SUBJECT: AMENDMENT NO. 80 TO FACILITY OPERATING LICENSE NO. NPF-3;
CYCLE 5 OPERATION

DAVIS-BESSE NUCLEAR POWER STATION, UNIT NO. 1

Amendment No. 80
License No. NPF-3

SAFETY EVALUATION BY THE OFFICE OF NUCLEAR REACTOR REGULATION
SUPPORTING AMENDMENT NO. 80 TO FACILITY OPERATING LICENSE NO. NPF-3

Figure 2.2-1 Trip Setpoint for Flux -- $\Delta\text{Flux}/\text{Flow}$

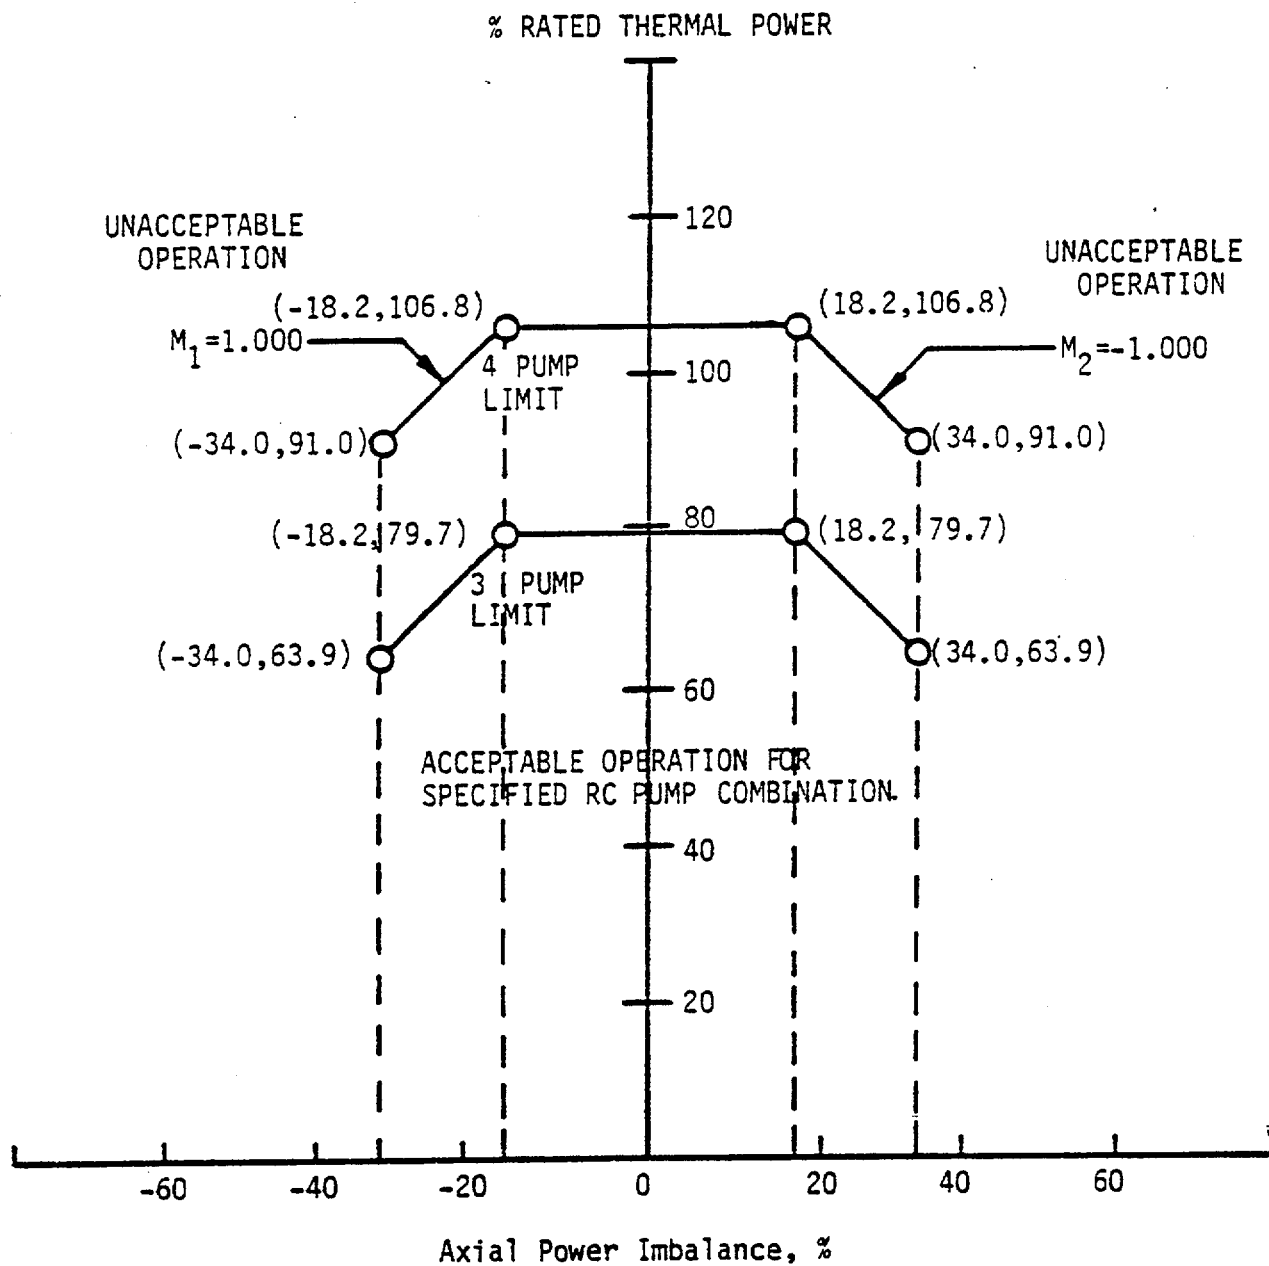
Curve shows trip setpoint for a 25% flow reduction for three pump operation (290,100 gpm). The actual setpoint will be directly proportional to the actual flow with three pumps.

Regulating Group Position Limits, 0 to 25+10/-0
EFPD, Four RC Pumps -- Davis-Besse 1, Cycle 5

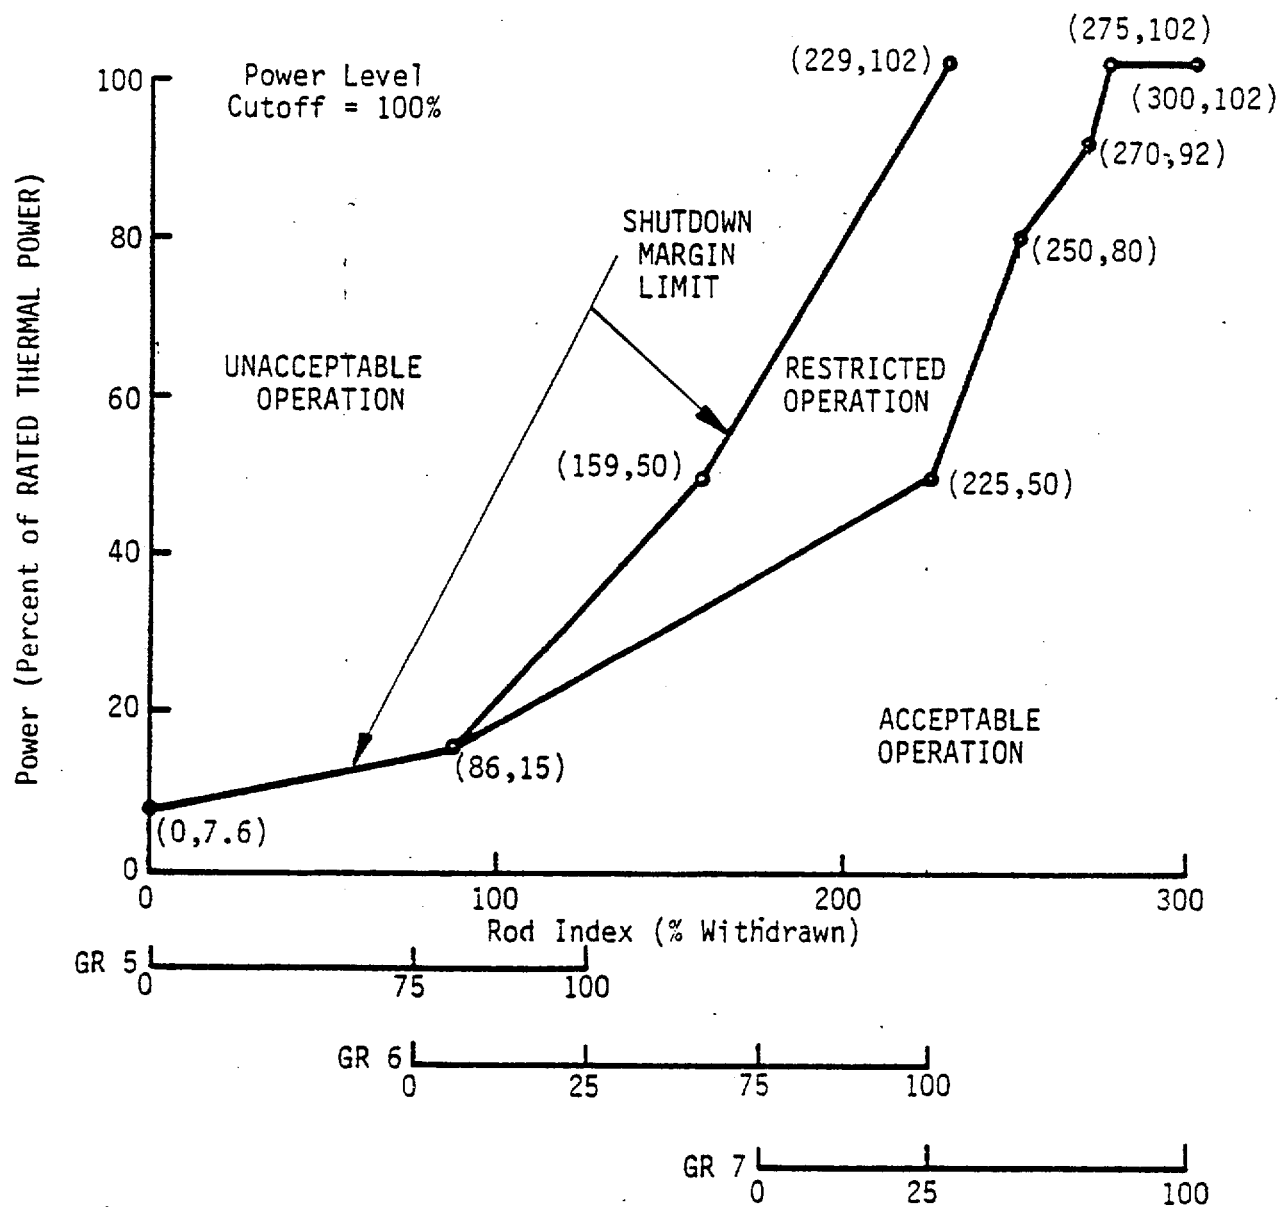
3.1.3.6 The regulating rod groups shall be limited in physical insertion as shown on Figures 3.1-2a, -2b, -2c, and -2d and 3.1-3a, -3b, -3c and -3d. A rod group overlap of $25 \pm 5\%$ shall be maintained between sequential withdrawn groups 5, 6 and 7.

Control Rod Core Locations & Group
Assignments -- Davis-Besse 1, Cycle 5

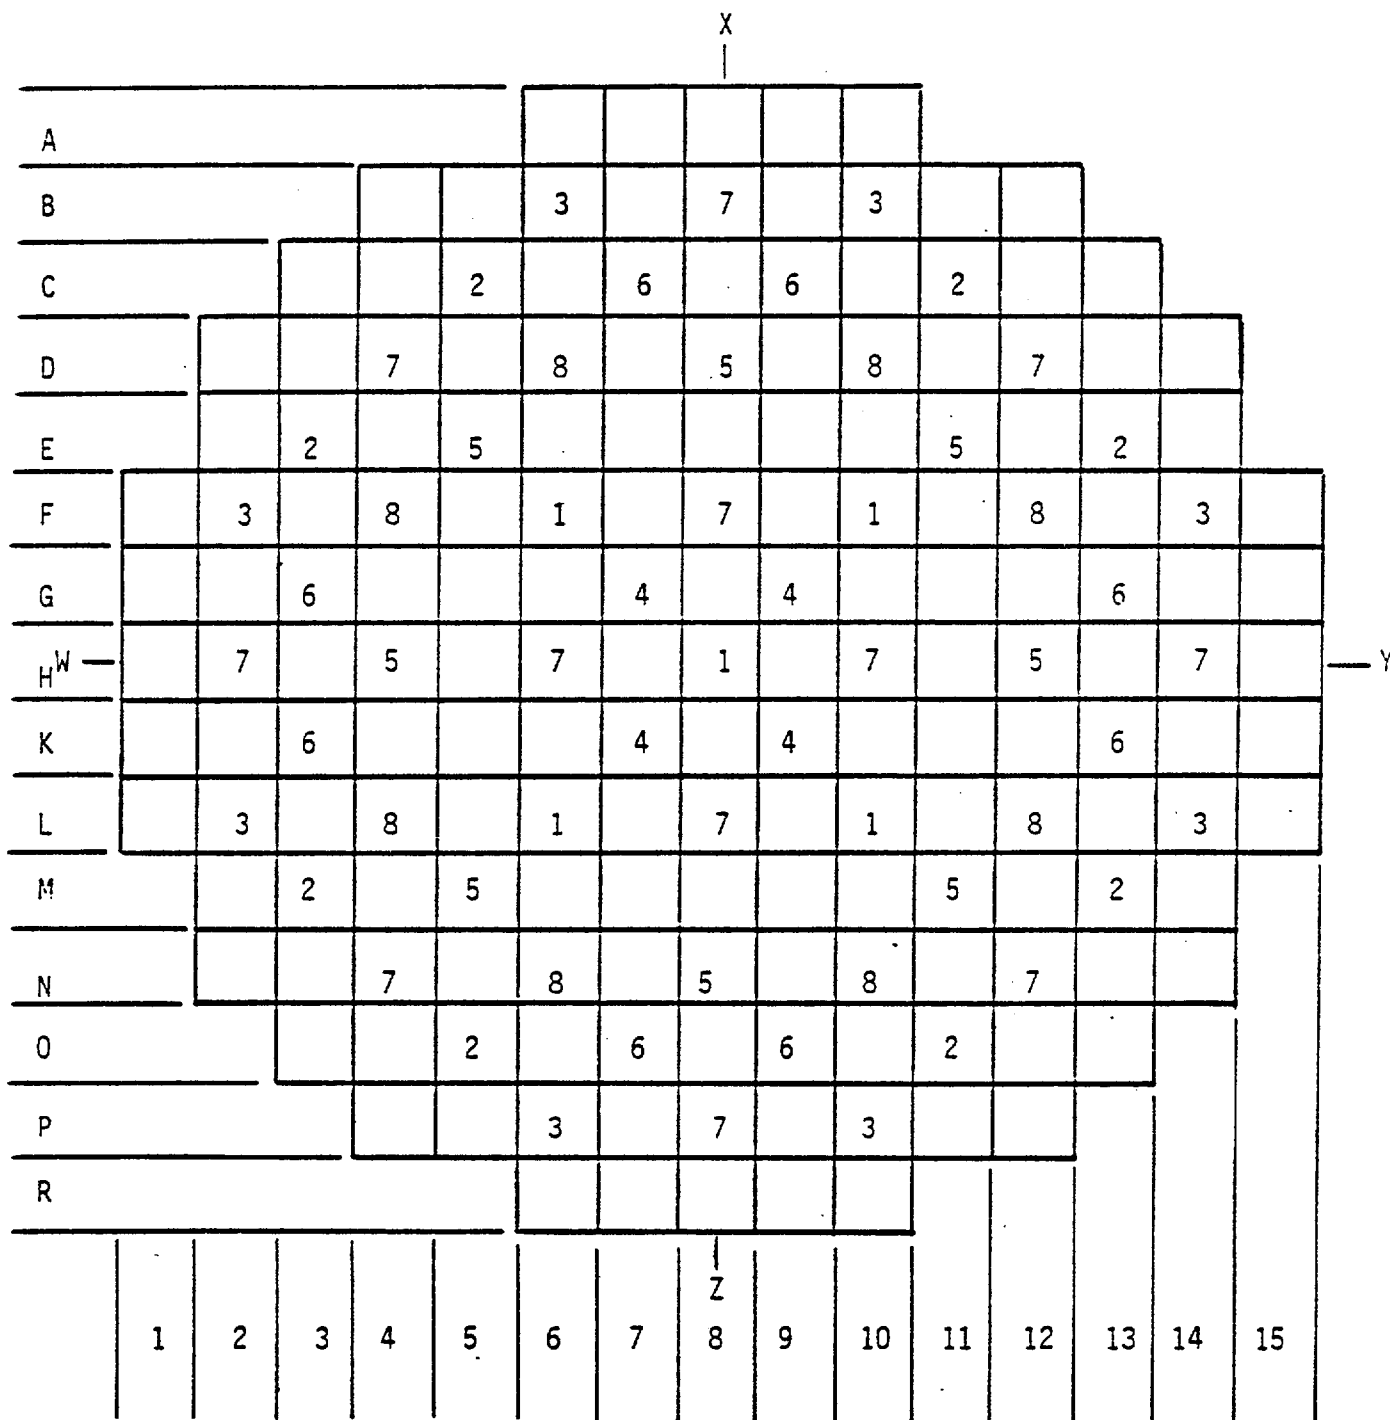
3.1.3.7 Each control rod (safety, regulating and APSR) shall be programmed to operate in the core position and rod group specified in Figure 3.1-4.
